R-85 Phonograph Record Changer Mechanism Adjustment

SERVICE BULLETIN

Phonograph Newsletter

OPTICAL SWITCH RESISTORS

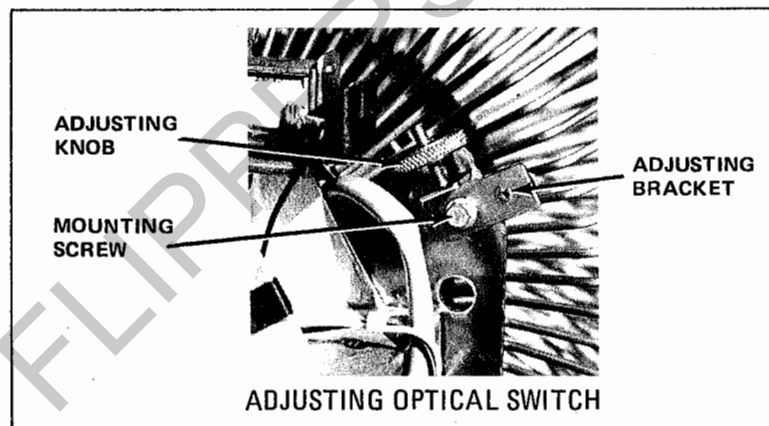
The Optical Switch 3-07944-01 electrical characteristics can degrade slightly per hour of usage. This could cause the mechanism to play a selection one to five selections beyond the correct selection. (For example, 110 is selected but 111 plays, even though the digital display indicates 110 should be playing.)

This situation can be avoided by changing the 1/4 watt resistors R 213 and R 215 in the Mechanism Control 4-07221-01 and -02 from 18K Ohm to 27K Ohm.

Mech. Control Assemblies with inspection stickers dated July 1981 or later will contain the 27K Ohm resistors.
